UNITED STATES PATENT AND TRADEMARK OFFICE

APPLICATION NO.	FILING DATE	FIRST NAMED INVENTOR	ATTORNEY DOCKET NO.	CONFIRMATION NO.
09/788,420	02/21/2001	Oh Nam Kwon	8733.388.00	5851

Office Action Summary	Application No.	Applicant(s)	
	09/788,420	KWON ET AL.	
	Examiner	Art Unit	
	George Y. Wang	2871

DETAILED ACTION

FIG.2

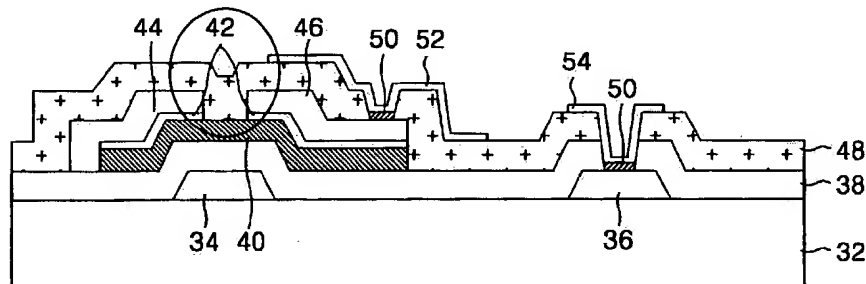
Applicant's first argument is that the second insulating layer of the Wakai reference does not teach "a hole exposing a portion of the third conductive layer." However, Examiner points out that Applicant's figure lacks a depiction of a conventional "hole." See Fig. 2 below:

Because the drawings do not show this "hole" feature as specified in the claims, Examiner has construed this "hole" to be a protrusion or filler that exposes the third conductive layer. Thus, Applicant's argument that the reference does not teach a "hole" is not persuasive since Applicant himself does not illustrate this claim. In fact, this "hole" limitation must be shown or the feature(s) canceled from the claim(s). No new matter should be entered.

FIG. 8

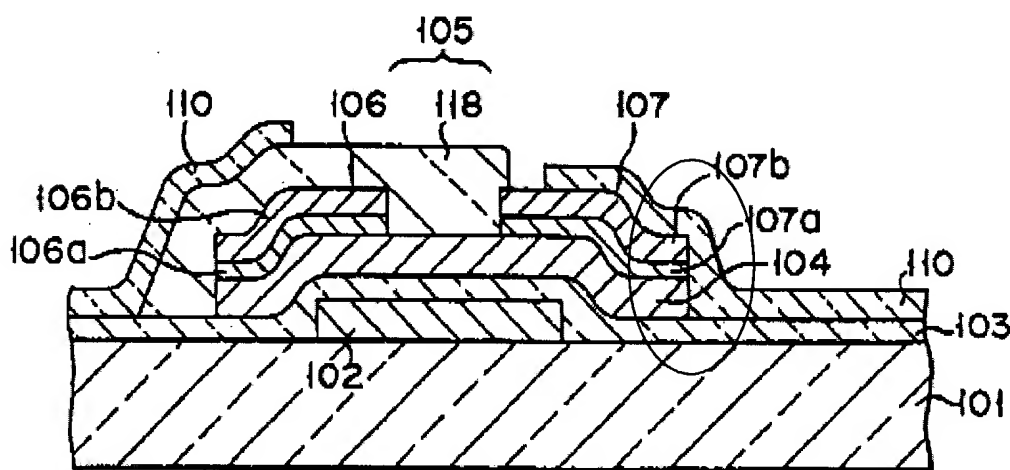
Applicant's second argument is that the Wakai reference does not disclose a fourth conductive layer on the second insulating layer and electrically contacting the third conductive layer. Examiner asserts that the Wakai reference does teach this in Fig. 8. See circled area below.

Accordingly, Applicant's arguments are not persuasive. The Wakai reference clearly teaches all the claimed limitations. Therefore, Examiner, holds to the validity of the Wakai reference and maintains rejection.
